# Answer to reviewer #2

We want to thank the reviewer for giving us the opportunity to submit an improved draft of the manuscript titled *Cost-benefit analysis of coastal flood defence measures in the North Adriatic Sea*. We appreciate the time and effort that you have dedicated to providing your valuable feedback on the manuscript. We have been able to incorporate changes to reflect most of the suggestions provided. We have enabled the track changes within the manuscript. The spelling and wording have been extensively revised following criteria of clarity, coherence and brevity.

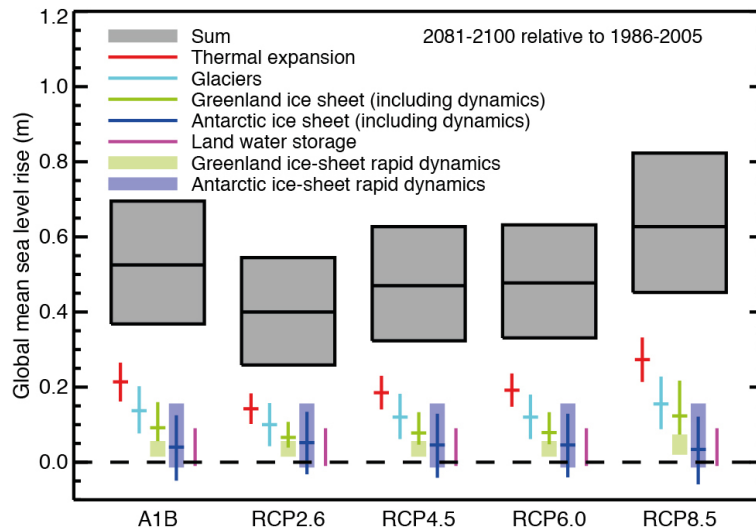
**Line150:** The authors used RCP4.5 for the future projections of SLR. It would be interesting to see what happens with RCP8.5.

- Thank you for this suggestion. It would have been interesting to explore additional SLR scenarios, however the scenario analysis was constrained due to time and funding limitations, which in turn depend on the preferences of the stakeholders. As a result, it has been agreed with the Municipality of Rimini to simulate only one RCP scenario (RCP 4.5, selected as the "average"), but to consider a wider range of flood probabilities in term of return periods (i.e. 1, 10, 100, and 250). We think the one scenario that could be added in future work to extend recommendations is the RCP 8.5 at 2100, as the same scenario at 2050 does not differ significantly in terms of global SLR with respect to the RCP 4.5, while the scenario RCP 6.0 doesn't differ in terms of SLR significantly also at 2100.

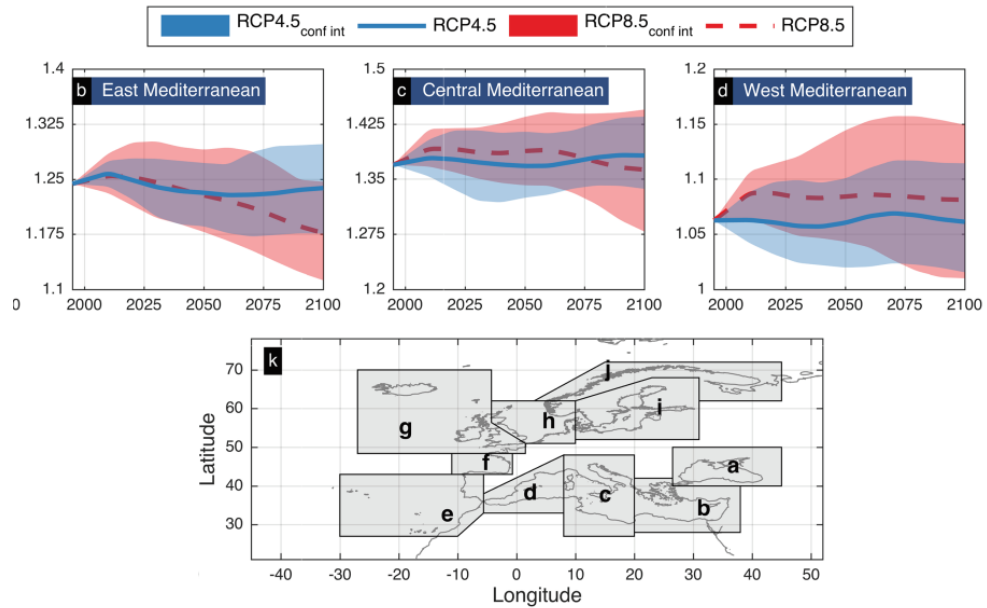
**Line 150-152:** Moreover, IPCC AR5 SLR projections give more local projected values of SLR. Apart from using a generic Global Mean Sea Level rise projection for the Mediterranean area, it would make more sense to account for more regional/local SLR values at specific coastal areas (as in IPCC AR5).

- Thank you for your valuable comment. We believe that in our analysis we do account for both local SLR historical observations at coast and specific downscaled projections for the central med basin. We have taken into consideration your comment and have amended par 3.3 to address these points more clearly:

The dataset obtained from [Vousdoukas et al \(2017\) - Extreme sea levels on the rise along Europe's coasts](#) currently represents the best SLR estimate available for EU countries:

Projections of RSLR indicate a statistically significant increase in MSL along the entire European coastline. The average RSLR across Europe is projected around 21 and 24 cm by the 2050s under RCP4.5 and RCP8.5, respectively. RSLR is projected to accelerate during the present century under both RCPs, reaching 53 and 77 cm by the year 2100 [...]. The RSLR projections show higher model agreement for the Mediterranean Sea and the Atlantic coast [...].
